**Masterson 24-Inch Water Main Extension**  
**Solicitation Number: CO-00177**  
**Job No.: 18-1018**

**ADDENDUM 2**  
**July 3, 2018**

**MASTERSON ROAD 24" WATER MAIN EXTENSION**  
 BEXAR COUNTY, TEXAS  
 SITE PLAN EXHIBIT

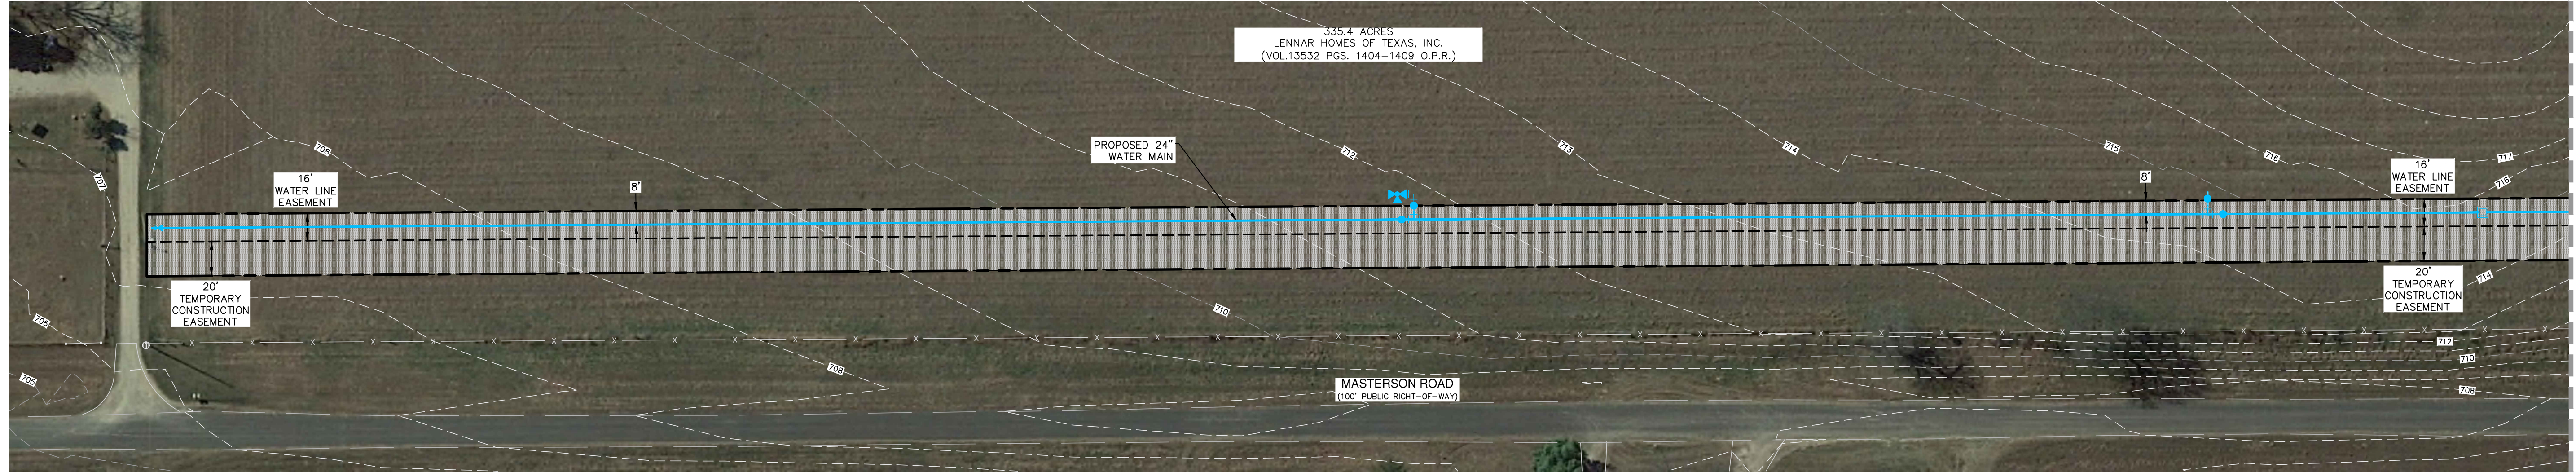
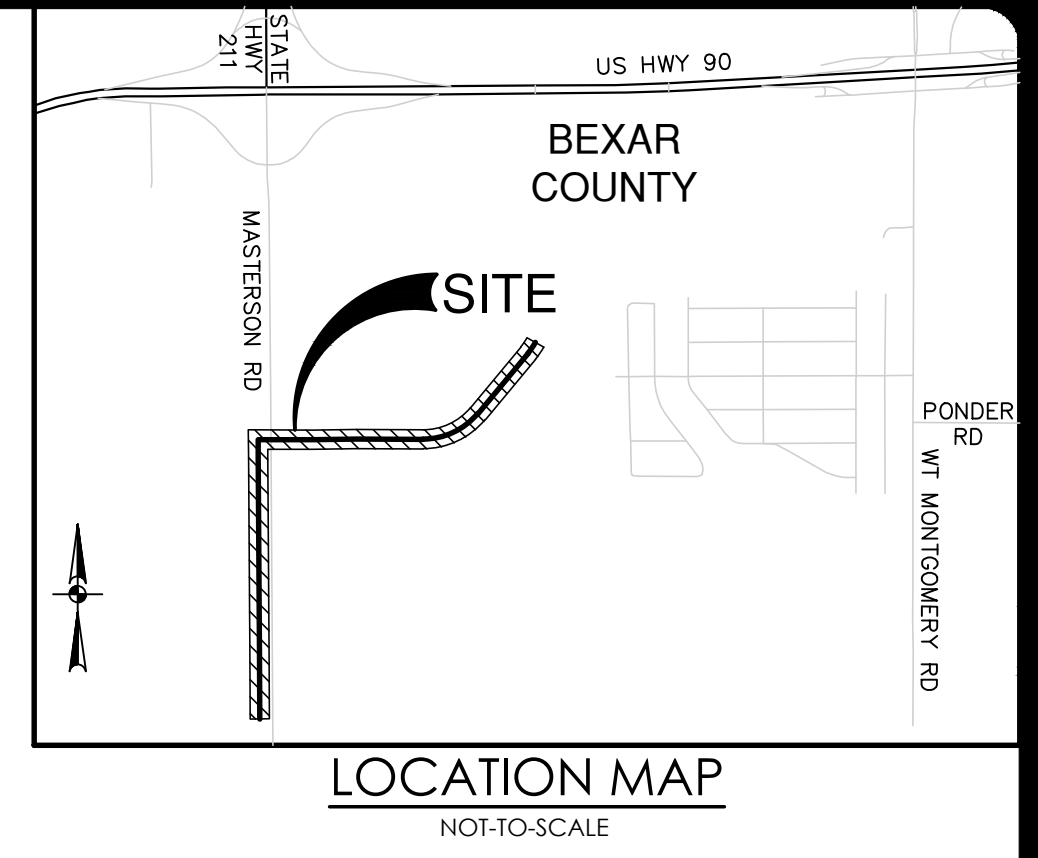
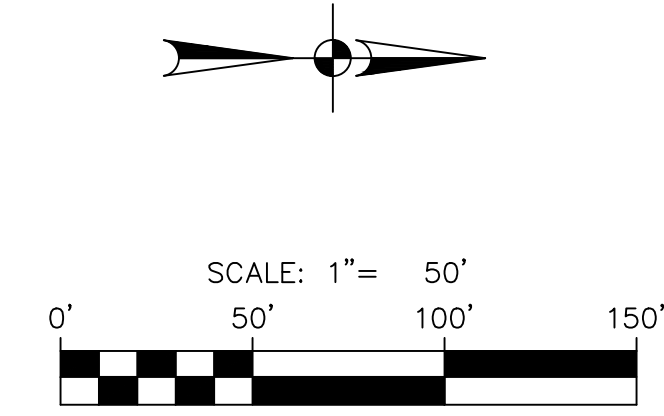
1. Bid Proposal – Remove the Bid Proposal in its entirety and replace with the attached. Note that the line items have changed. The updated version should be used by Bidders when submitting a response for the project.
2. Site Plan Exhibit – An aerial map with limits of tree plan is now included for reference.

**Question 7** – Bid Item #3 is for a Tree Protection Plan. Can an overview aerial map be provided so that the limits of any tree clearing / protection can be determined?

*Response: Aerial map with limits of tree plan is attached.*
